Access Compliance Report Public Rights-of-Way (Curb Ramps)

Main Street: ST_ALBANS_DR Cross Street: SILVER_FOX_RD Location: NW

ADA ID: RPRK211220122722 Ramp Type: Type 1 - Perpendicular Diagonal Initial Pass/Fail: Pass Overall Compliance: No Severity Score: 10

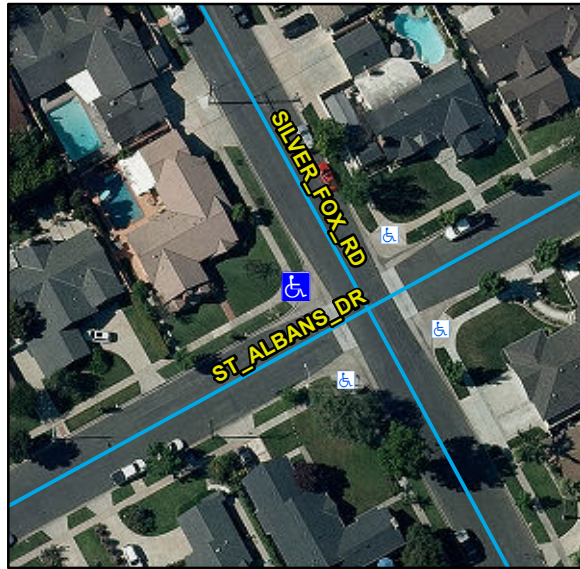
Remove & Replace Curb Ramp With Two New Directional Ramps or Equivalent.

R204.3, R304.2.2-Perp, R304.3.2-Para, R305, STD 1115
